REZONING SNAPSHOT: Z2025-25

REZONING APPLICATION ANALYSIS

ZONING CASE #: Z2025-25

ZONING PLAN-2

Potential outcome for the combination of Lots 3 & 4 under Infill Regulations

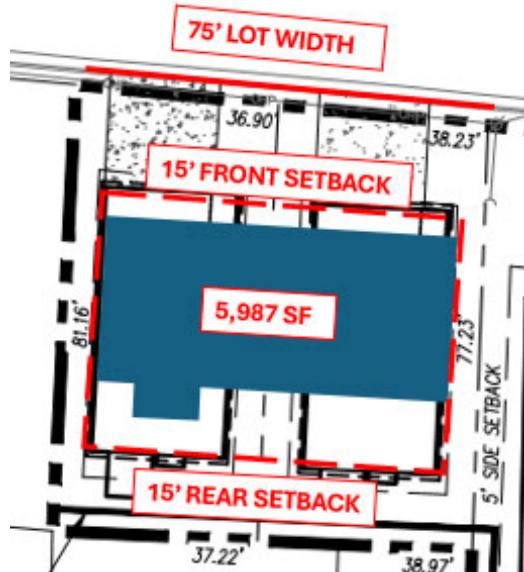
Furthermore, if Lots 3 and 4 were combined into a single parcel with a horizontally oriented home, as illustrated below, **three of the four** remaining variances could be eliminated entirely.

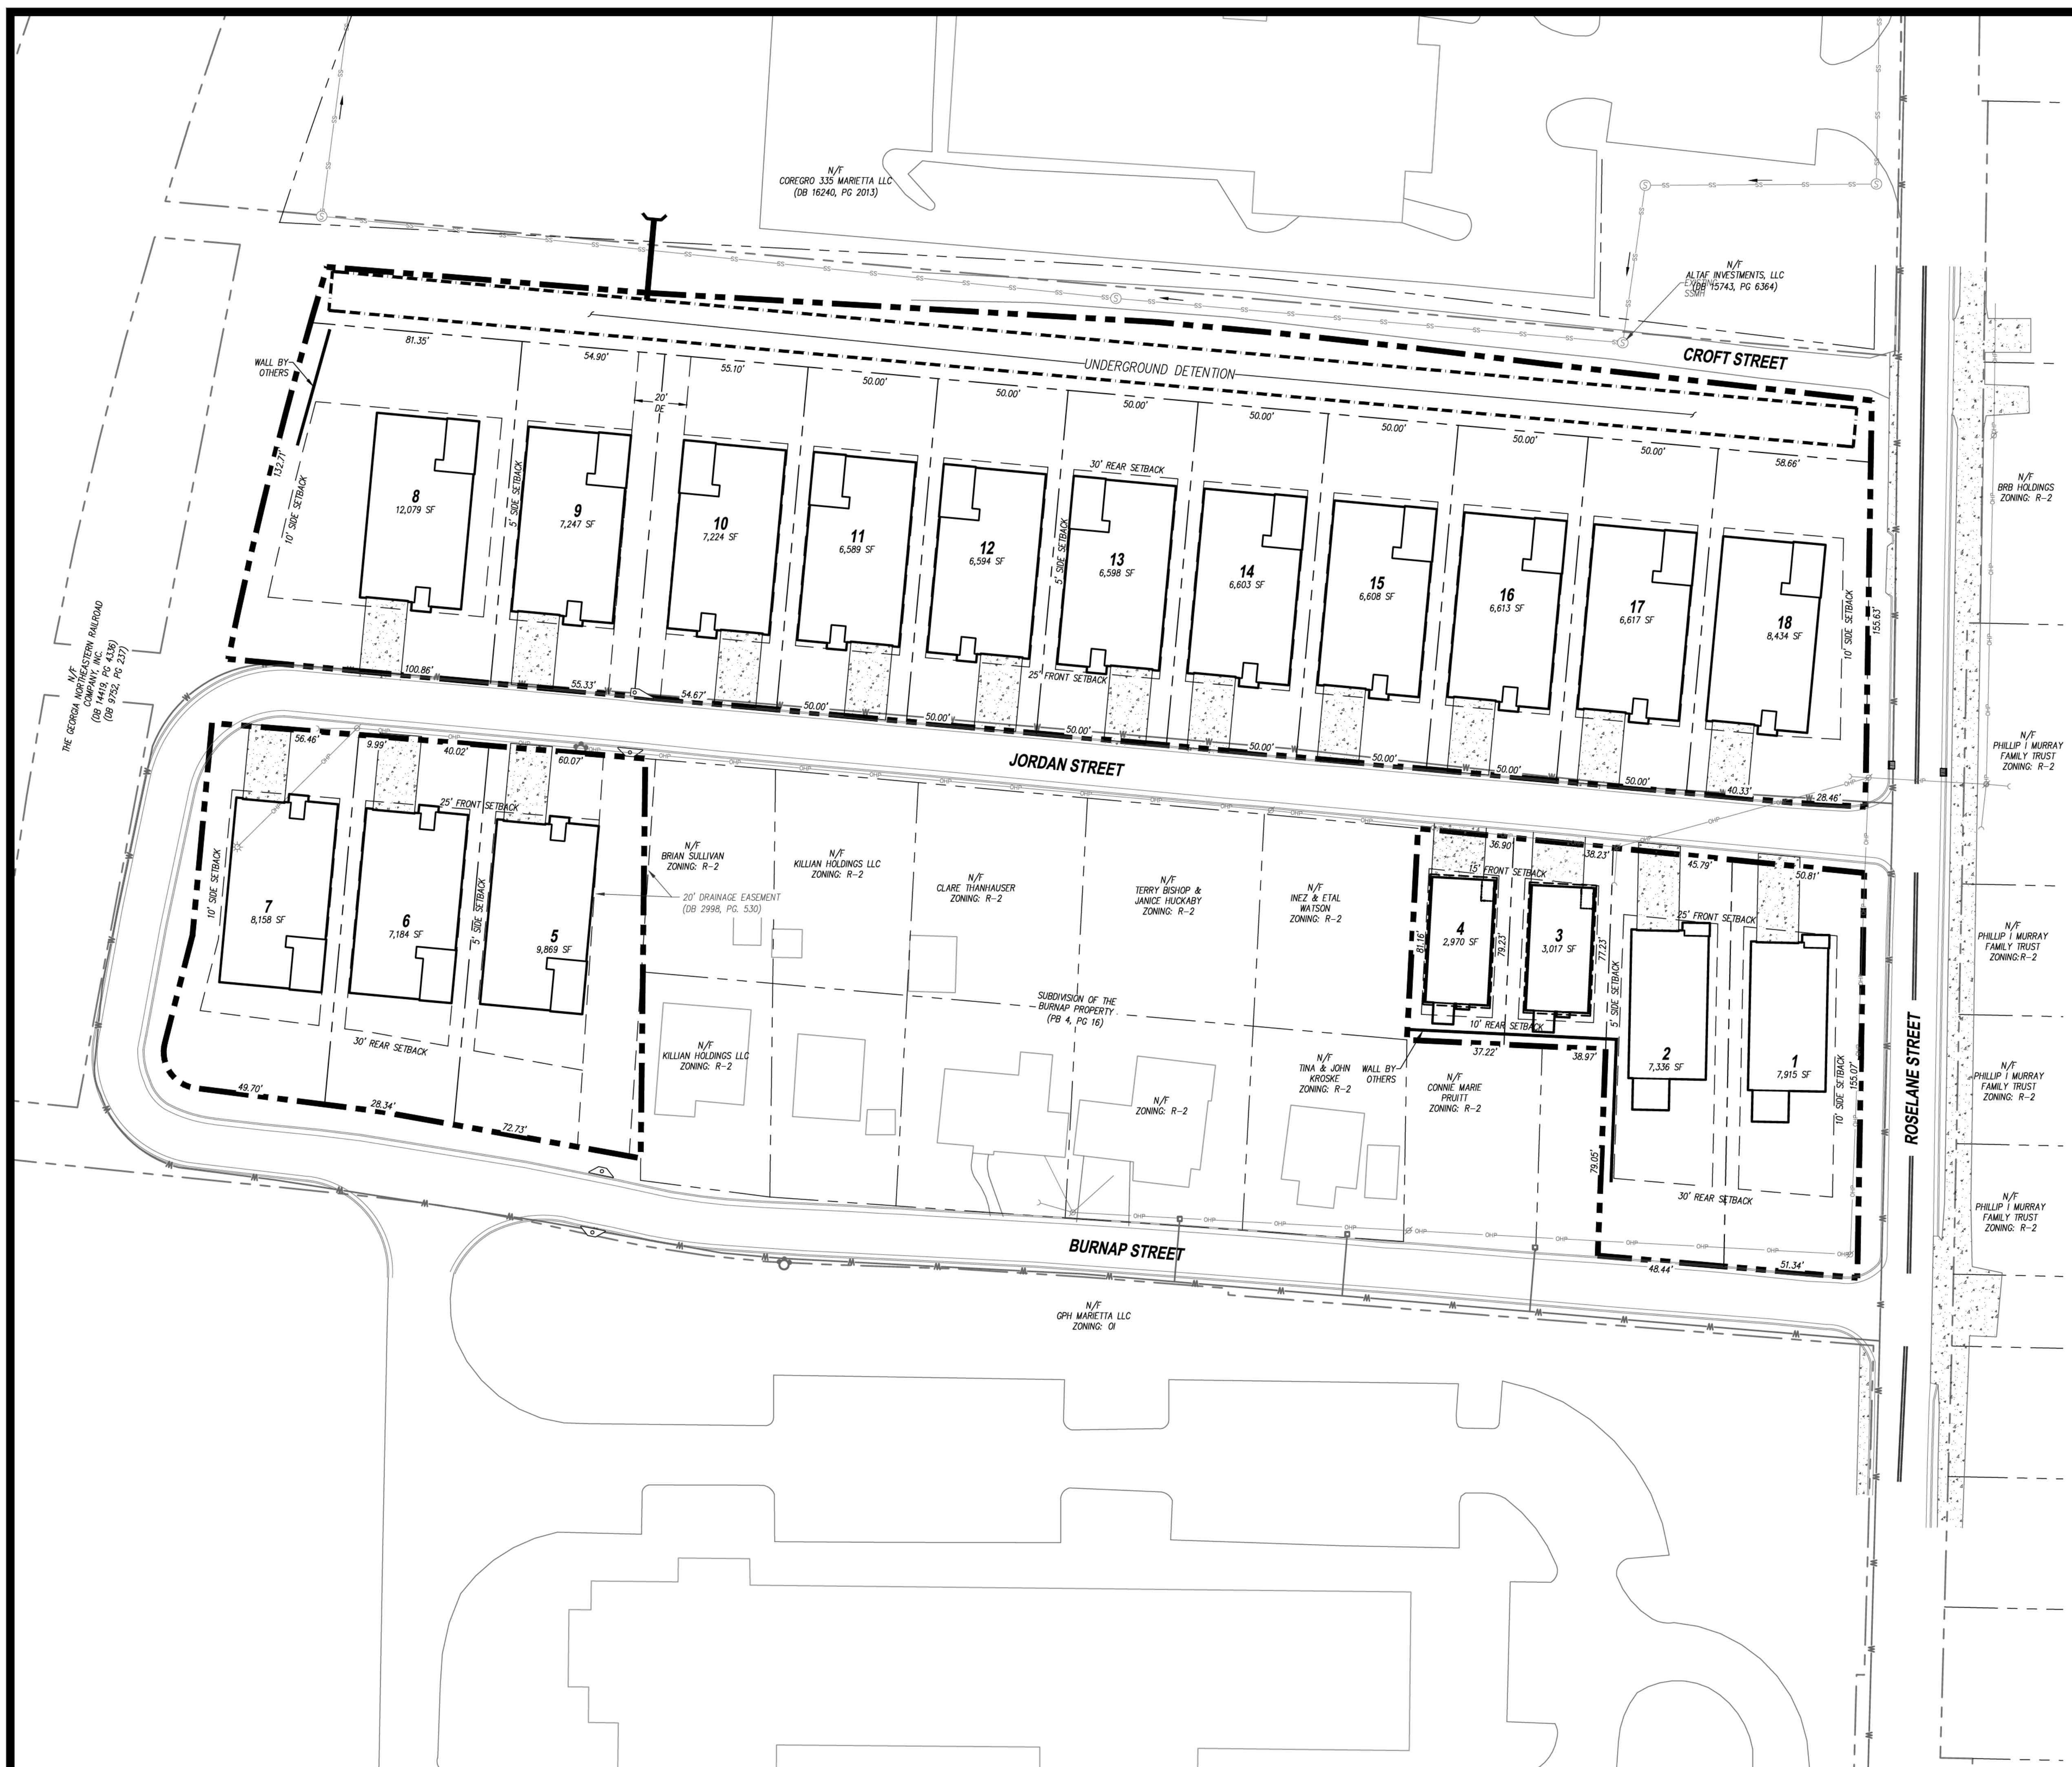
Proposed density of 5.5 units/acre exceeds R-4 standard, the layout aligns closely with City's Residential Infill Overlay standards. Applying the overlay would reduce variances and introduce mandatory design elements – like enhanced architecture, landscaping, and pedestrian improvements – not typically required under R4 zoning.

Jordan Street does not meet right-of-way or paving width standards. Sidewalks are missing from the site plan. Sanitary sewer extension from Croft Street is required.

**A significant portion of these variances – specifically five out of ten – are associated with Lots 3 and 4. These could be substantially reduced or eliminated if the two lots were combined into a single parcel, with the home oriented horizontally rather than as two narrow vertical units.*

The Fire Department and Public Works have identified concerns related to the width of Jordan Street in their reviews. Jordan Street currently has a 20-foot right-of-way width and 17-foot paved width. Newly developed streets are required under Section 730.01 (F) to have a 50-foot right-of-way width and a 24-foot paving width (measured from back of curb).

The site plan submitted with the rezoning request does not show the incorporation of sidewalks; however, they are required along all streets for new developments. City standards call for a 5-foot-wide sidewalk with a 2-foot grass strip. *At minimum, the proposal should include continuation of sidewalk along Roselane Street.*

There is no existing sanitary sewer access along Jordan Street, Burnap Street, or Roselane Street. The only available connection is located along Croft Street. As confirmed by Marietta Water, a new sanitary sewer main will need to be installed as part of this project to serve the proposed lots.

Overhead utilities run along the south side of Jordan Street. New connections to existing overhead utilities will be required to go underground should the project be approved. No vertical structures could be built within 10 feet of any overhead power lines.

The current site plan shows the underground detention discharging to the neighboring property at 335 Roselane Street. An easement will be required to allow discharge into the off-site detention pond.

- Variance to allow Jordan Street to remain as existing and reduce the required right-of-way width from 50 feet to 20 feet and paving width from 24 feet to 17 feet.
[§730.01 (F. Table L)]

- Variance to waive the requirement of sidewalk installation along Jordan Street.
[§732.02 (F)]
